Staff Report & Recommendation

Historic Preservation Board

DATE: February 9, 2016

SUBJECT: HPB File No. 7602, **3120 Collins Avenue.**

2-story Garage

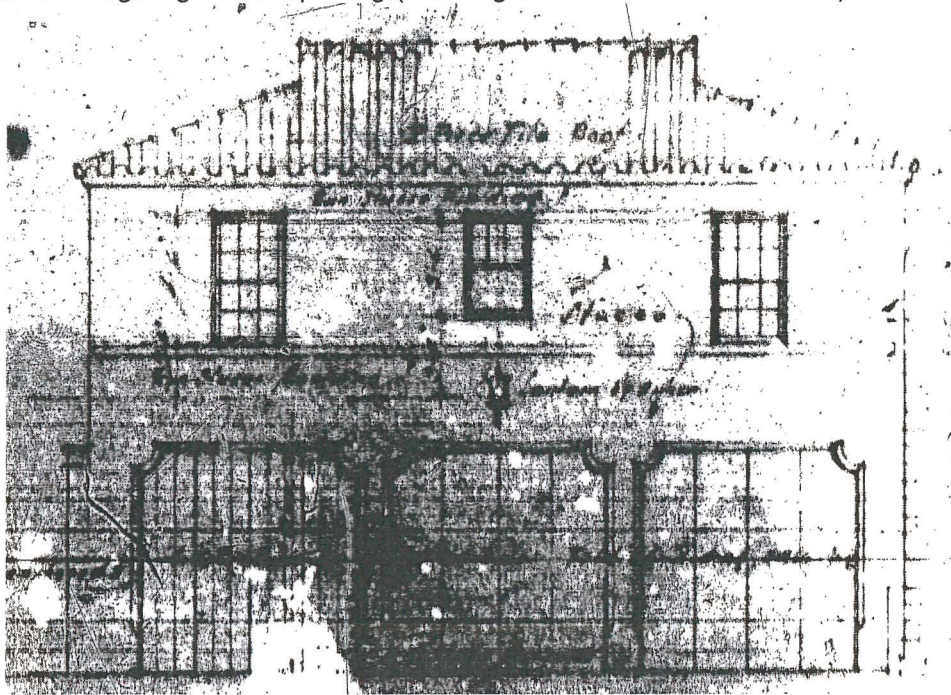
The 2-story garage structure is located behind the main house and is accessed via 32nd Street. The building originally contained a 3-car garage on the ground floor and an apartment unit on the second floor. The structure remains substantially intact with the exception of the enclosure of the easternmost garage door opening (see original north elevation below).

The applicant is proposing to change the use of the structure from multifamily residential to an accessory 59 seat restaurant with outdoor seating. The ground level will be converted into a kitchen and bar counter and the second level will be utilized as an office and storage area. The majority of the seating for the restaurant will be located in the proposed outdoor dining area adjacent to the north. Additionally, the applicant is proposing to construct a trellis structure with a retractable awning over the proposed outdoor seating. Although staff is not opposed to introduction of this shade structure, staff would note that the proposed materials have not been identified on the plans and that extent of the trellis is not shown consistently within the elevation

drawings, renderings and the proposed floor plan. Within the two remaining garage door openings the applicant is proposing to install French style doors with sidelights. Staff has no objection to the modification; however, staff is concerned with regard to the lack of detail provided. On the proposed elevation drawings and renderings the garage door openings no longer show the rounded corbel details at the corners of the openings and the openings appear to be different widths.

Finally, staff is extremely concerned that the applicant is not proposing any exterior restoration of the garage structure.

1. All exterior windows be removed and replaced with impact resistant single hung windows consistent with available historical documentation and the removal of the inappropriate through-the-window air-conditioning units to be replaced with a central air-conditioning system.
2. The original third garage door opening of the 2-story garage structure shall be full restored or a 1" blind recess shall be provided in the location of the original door opening.
3. The vehicular gate which was located along the north property line leading to the garage shall be recreated in a manner consistent with available historical documentation.
